MAY 03, 2010

ADDENDUM 4

Project: NMHU Student Union Building

From: Studio Southwest Architects

SOUND ATTENUATOR SCHEDULE

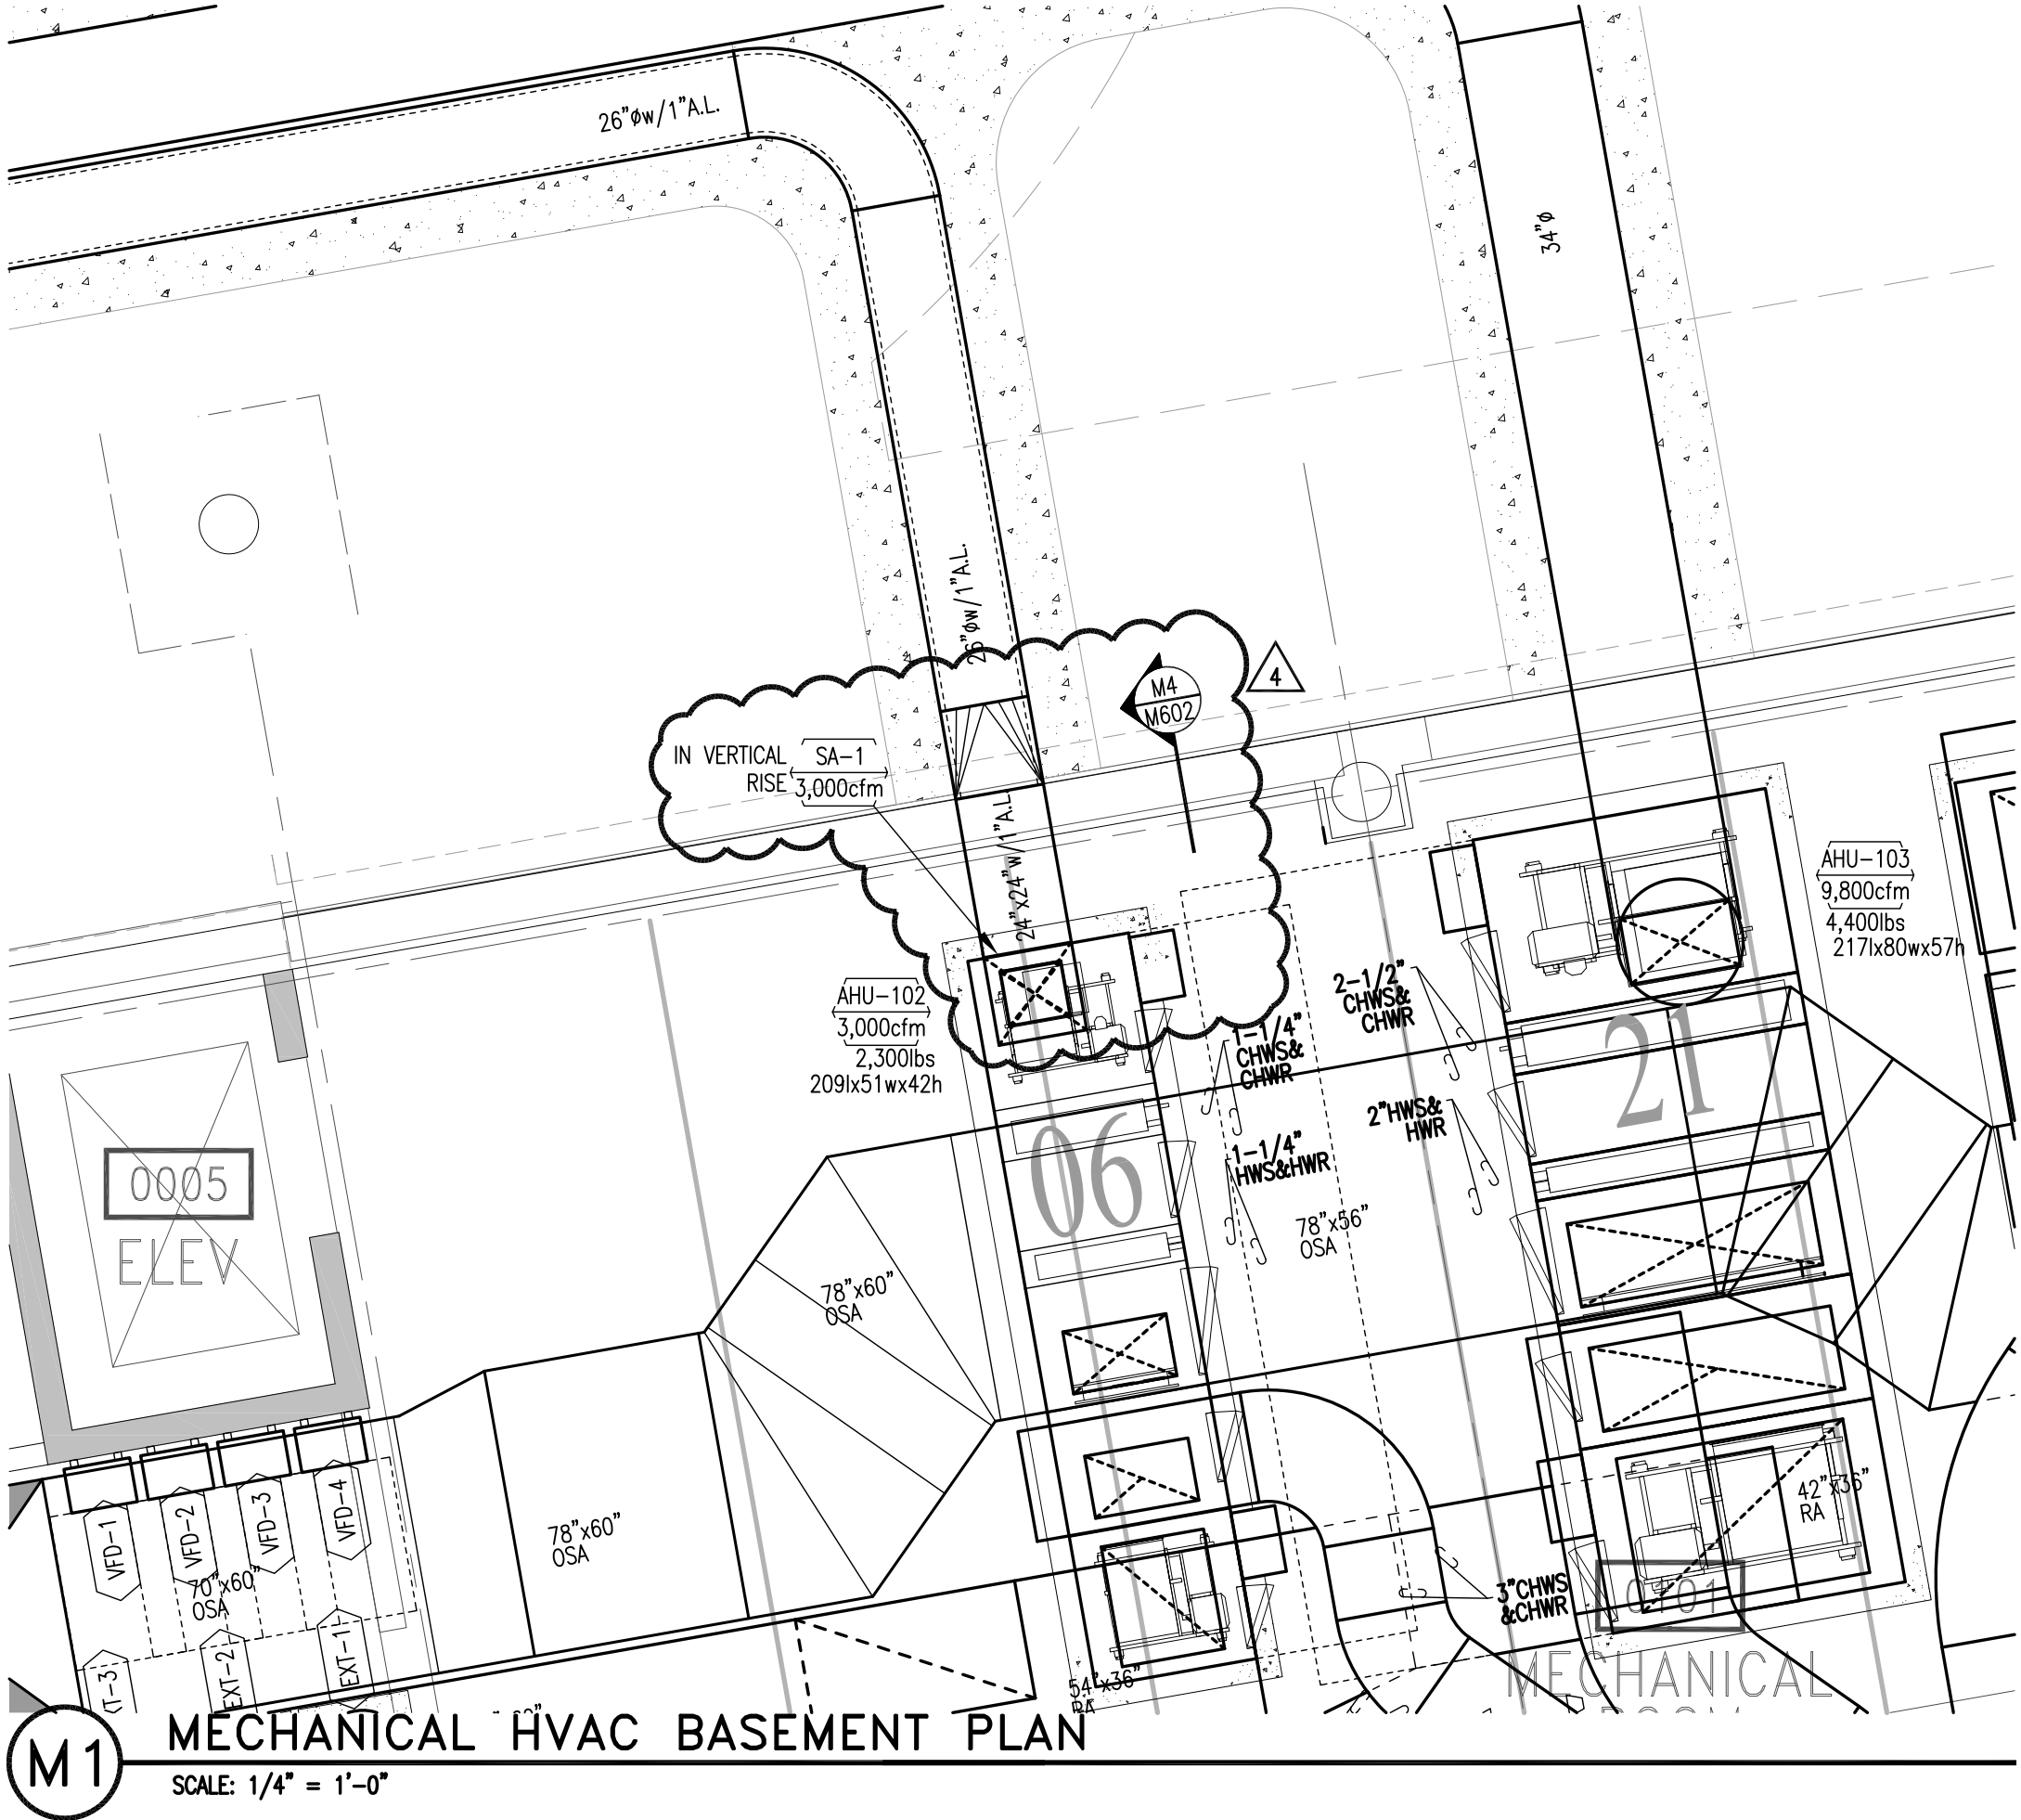
- **Add** Sound Attenuator Schedule per SK1.

MECHANICAL HVAC BASEMENT PLAN

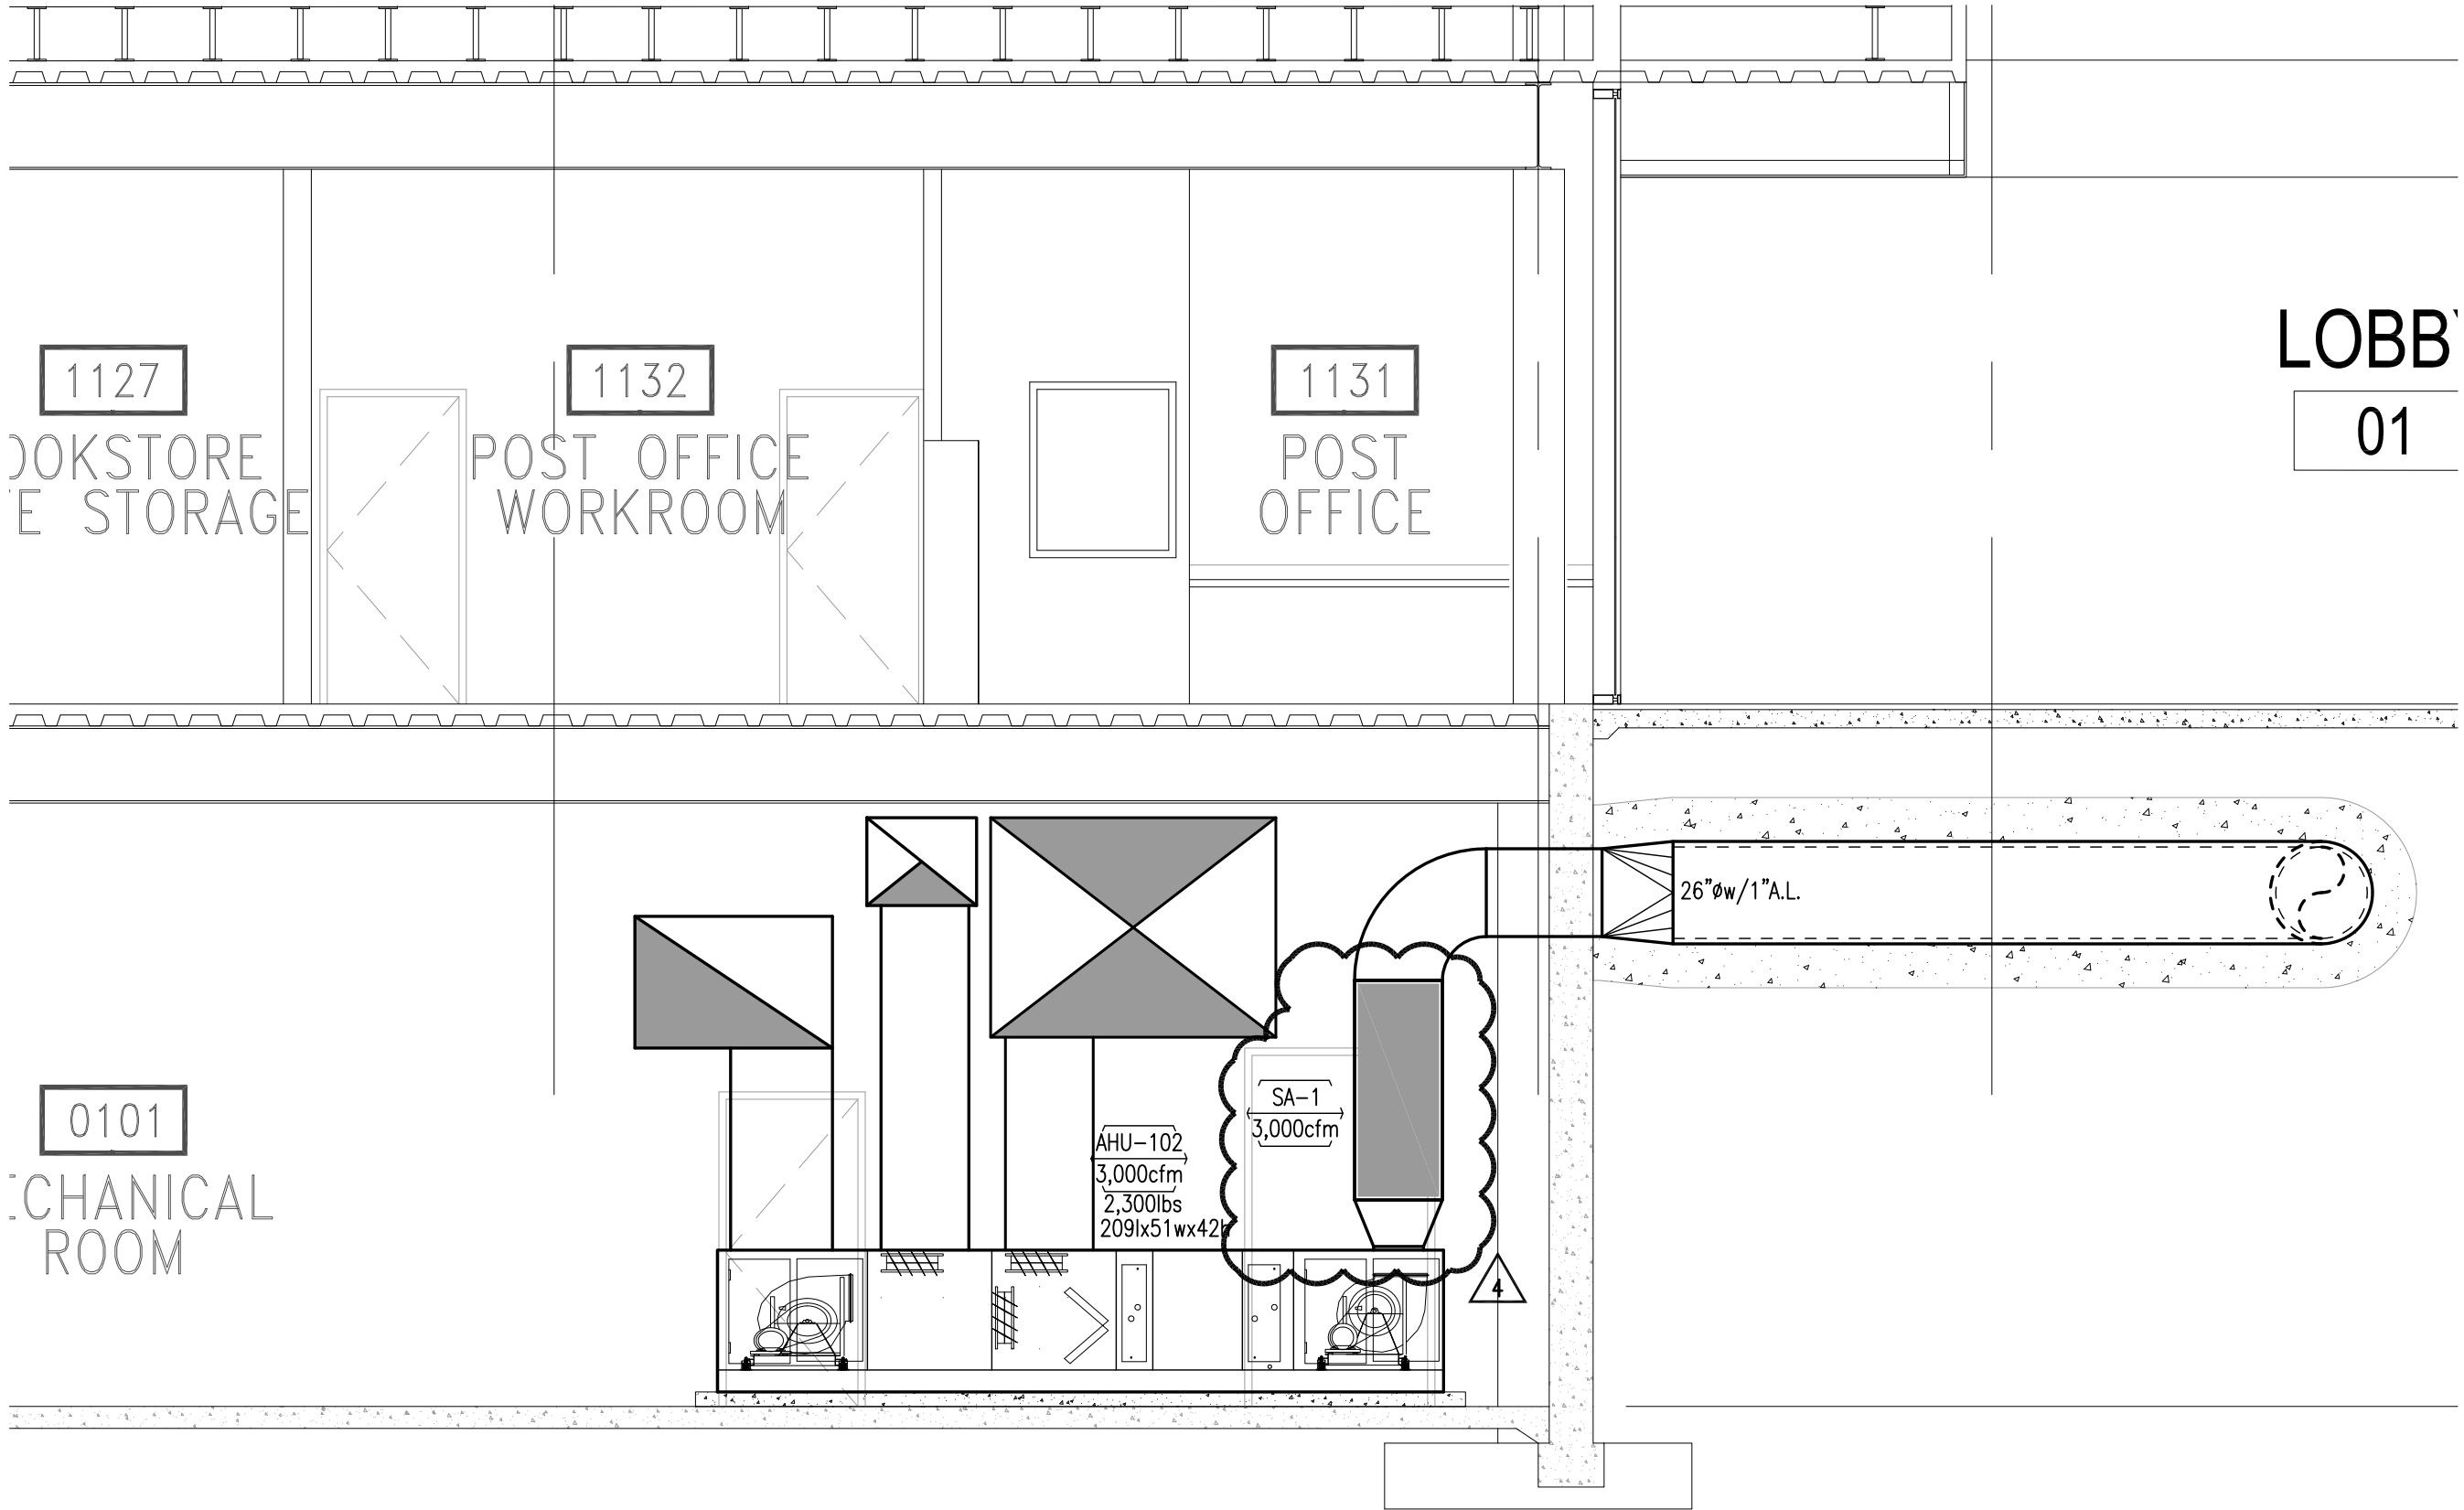
- **Add** Sound Attenuator SA-1at AHU-102 per SK2.

MECHANICAL HVAC SECTION THRU BASEMENT

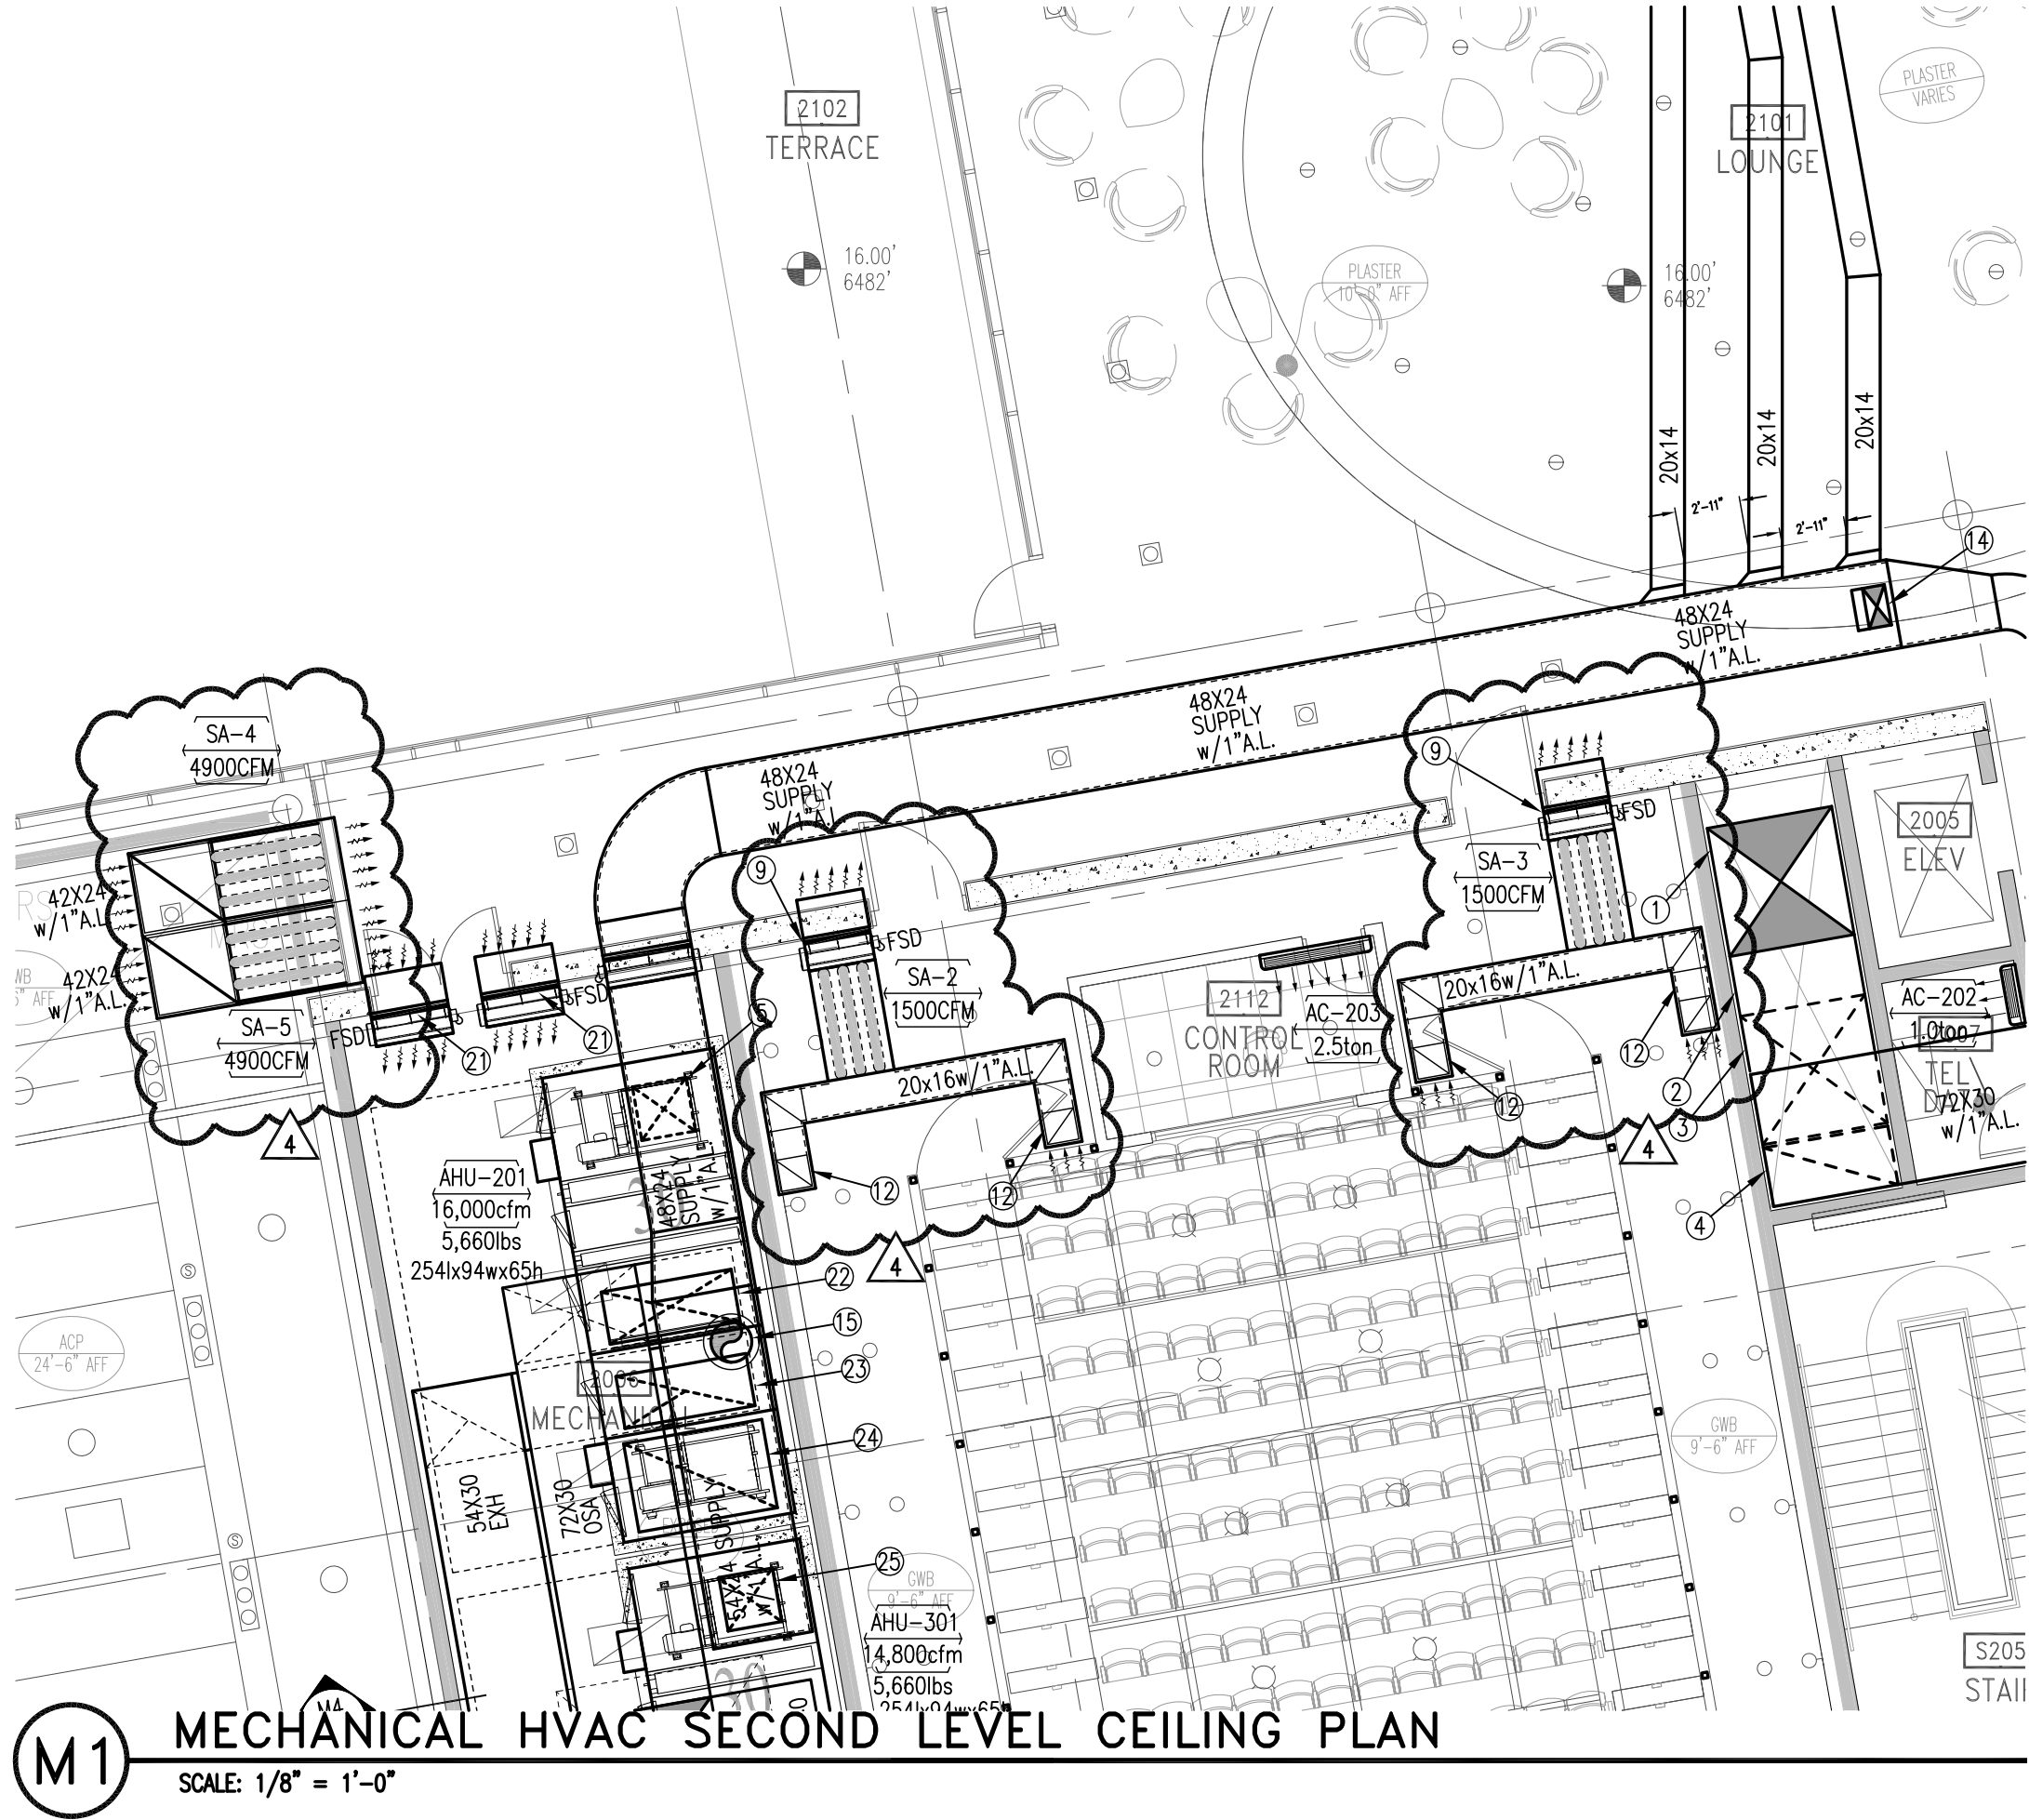
- **Add** Sound Attenuator SA-1at AHU-102 per SK3.
